KALABAGH BRIDGE CONSTRUCTION.

DISCUSSION.

He remarked that the Paper on the Kalabagh Bridge Construction dealt with the history, design and progress of construction to the end of the working season 1929-30.

KALABACH BRIDGE. VELOCITY CURVES.

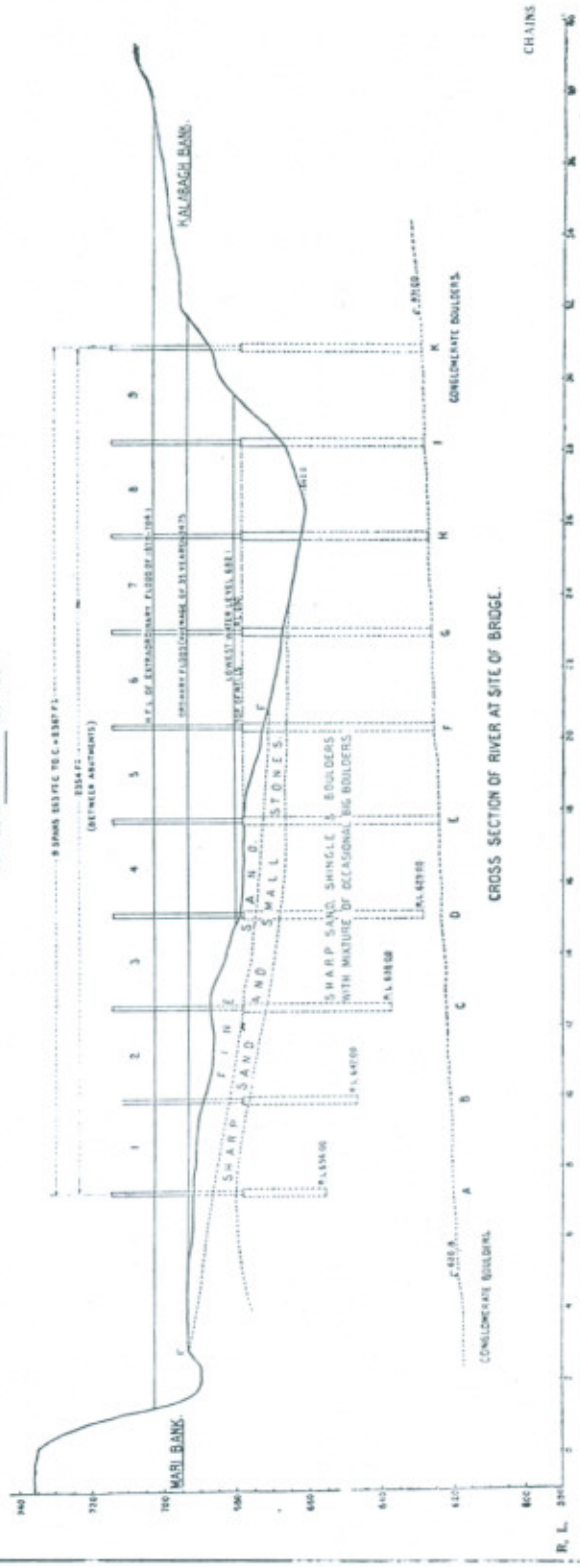
He had said that the modern tendency was to approach the limit in the contraction of railway bridge waterways. A glance at Plate II showed that the Kalabagh Bridge was very differently sited from bridges in alluvial plains. The river issued from a gorge in a clearly defined curved expansion. There was no wide trough in which the river flowed, and the banks at the bridge site did not necessarily indicate, as they might elsewhere, the limits of the vagaries of the river from one big flood to another but more probably showed, as the discharge and also the scoured cross section suggested, that in this instance Nature had provided her own training works, and the banks had possibly been generated, not one at one time, and the other at another, but simultaneously at some previous very high flood.

*KALABAGH BRIDGE CONSTRUCTION
BOULDER FACE MARI CLIFF*

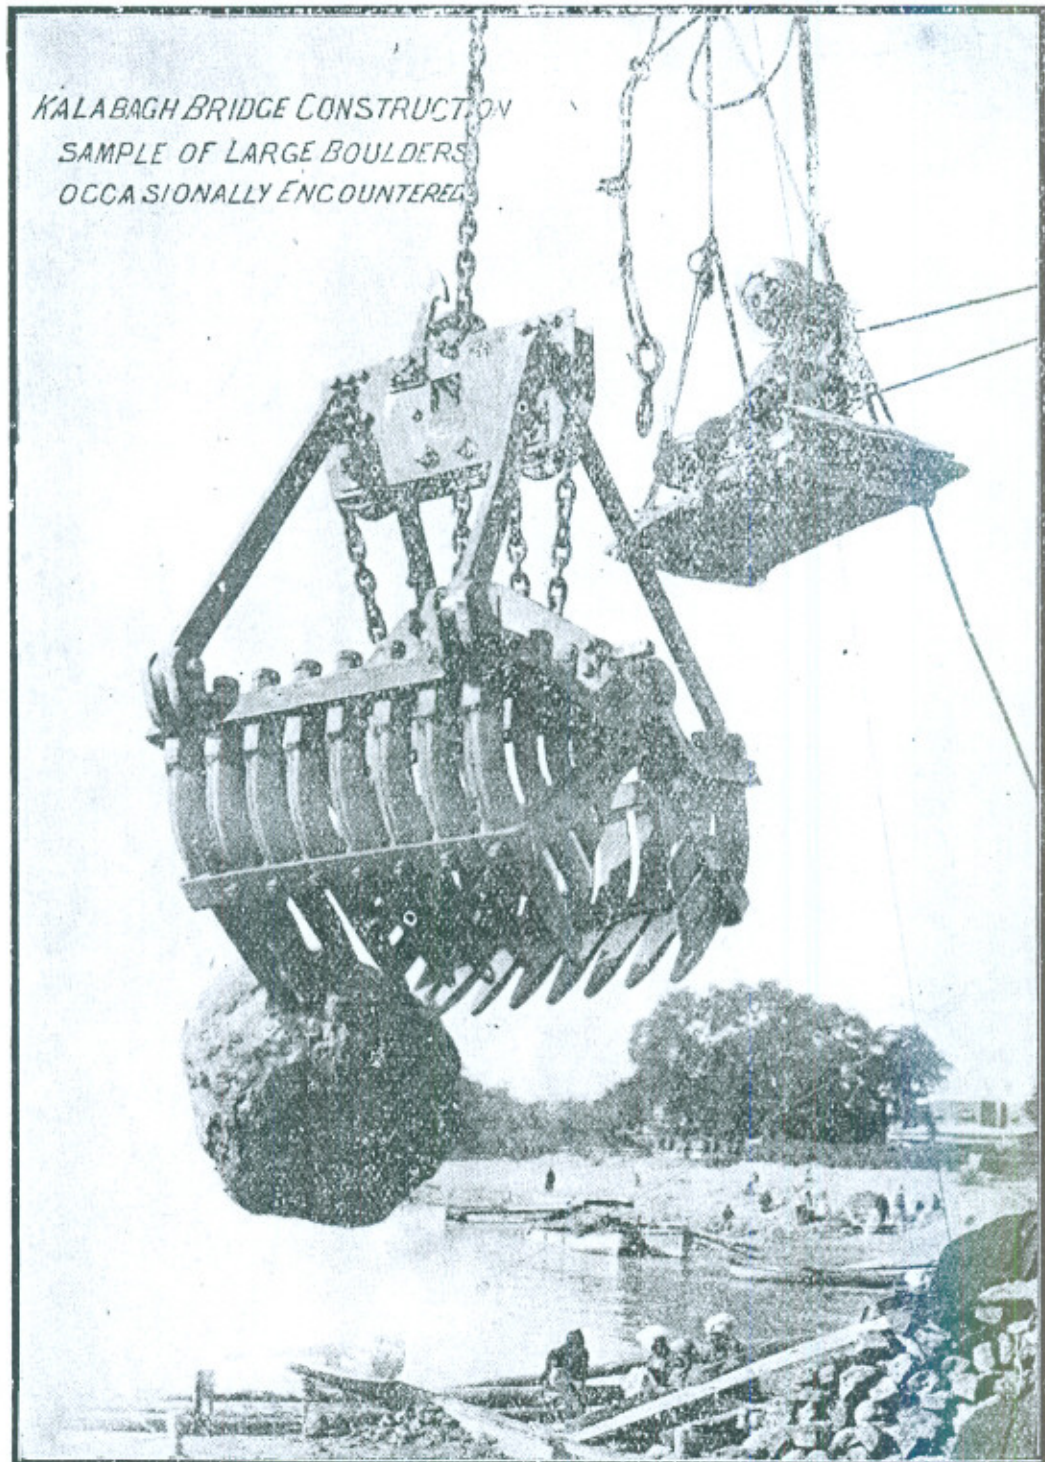
The photograph showing the boulder face of the Mari cliff gave an excellent idea of the material which was probably encountered when the river bed was deeply scoured. The Author had stated in the paper that the boulders in the river bed varied from small boulders about three inches in diameter to bigger ones as large as eighteen inches in diameter. That meant that the large boulder in Photo 3 was of the order of eighteen inches. He suggested that photographs of this character were enhanced in value if a foot rule, or any object which lent scale, such as a rupee, were placed in the same vertical plane as the subject of the picture.

It would have been clearer, as Mr. Lacey suggested had some scale been given to Photo No. 3. The largest boulder was 2½' to 3' in dia.

C. C. CORE BOX
FOR 10 TON BLOCKS

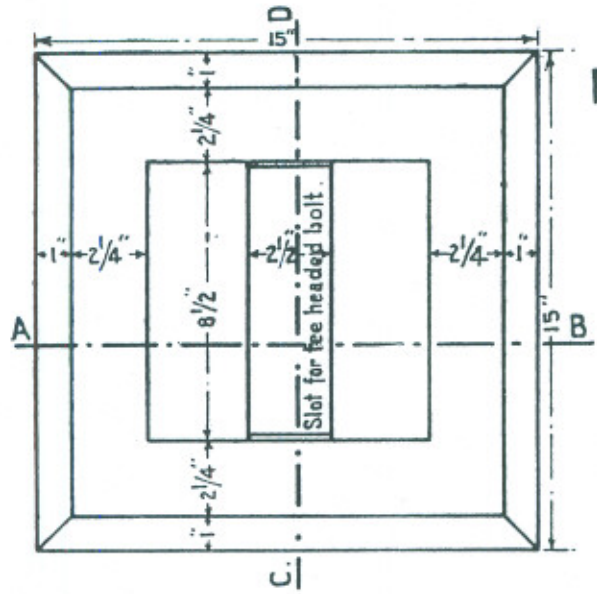
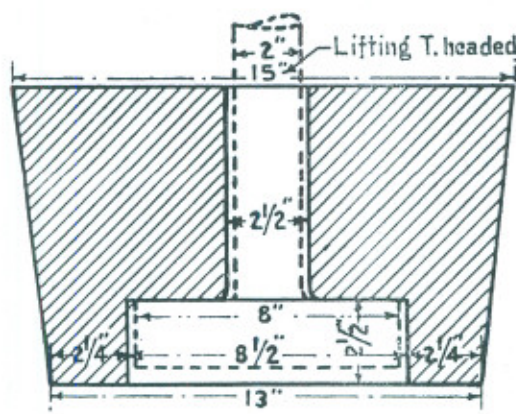
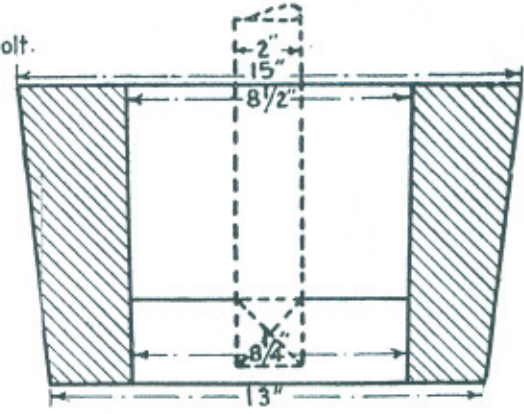
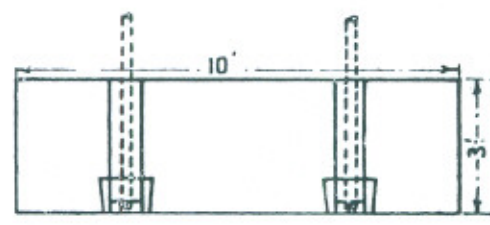
With reference to the concrete blocks referred to on page 73, the speaker asked what forms were used for making the recess in the underside of the concrete blocks for taking the T headed bolts. He explained that at Sukkur, wooden forms were, in the first instance, used, but it was found that in spite of thorough greasing and soaking before use, these wooden forms swelled in the concrete and were extremely difficult to remove, the bottoms in particular nearly always remaining stuck to the concrete. This necessitated making fresh forms for almost every recess; moreover when the block was lifted with the T bolt, the portion of the wooden form remaining in the hole became crushed and splintered, and this made it difficult to withdraw the T bolt after lifting. To overcome this difficulty, a special form made of concrete, in the shape of a small box, with the slot for the T head cast into it and the necessary recess below was made as a separate unit, and these concrete forms or boxes were spaced on the moulding floor, inside the form of the main block, before the latter was cast. The concrete form being heavy, kept its position on the moulded floor, without any holding arrangements, while concrete was being poured for the main block; and it also served as a guide and support for the taper plug used to form the slot for the T headed bolt right

through the main block. The concrete form, or box then became, and remained as, a permanent integral portion of the main block. The cost of this concrete form was less than that of a wooden form, so that the whole cost of the forms was saved and the resulting recess and bearing for the T headed bolts was most satisfactory. Attached sketches illustrate the arrangement.

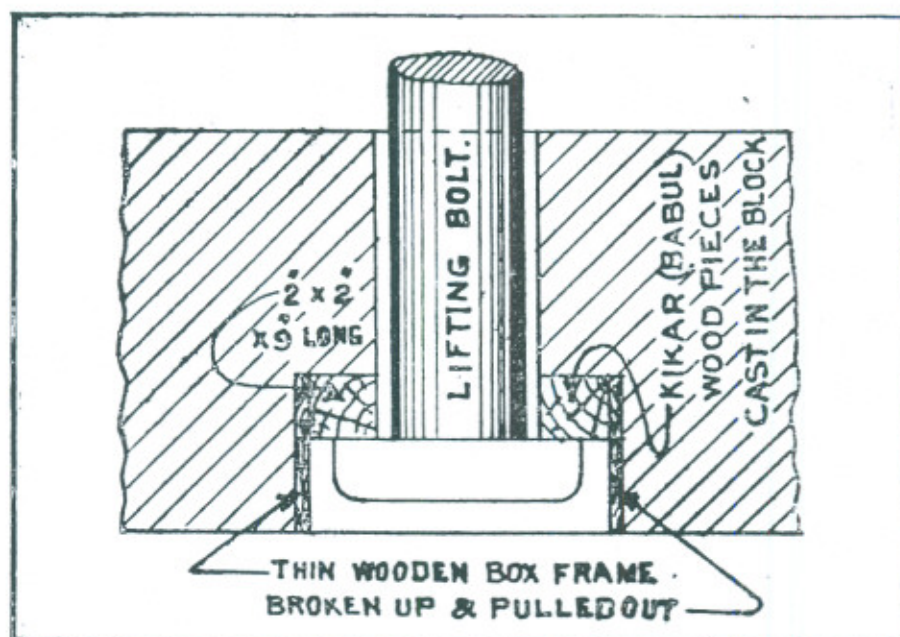
As far as the handling of the blocks was concerned, this was done as shown in the following sketch :—

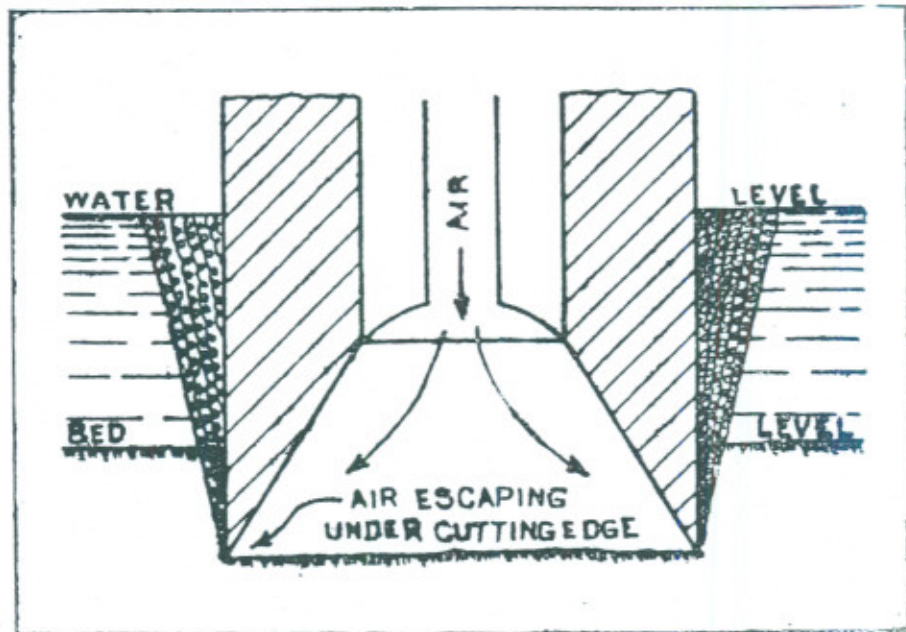
As far as the ventilation of the working chamber was concerned, no special ventilation was necessary as the air passed under the cutting edge of the caisson. There was thus a continuous flow of air and a special means of ventilation was not required. (See sketch below).
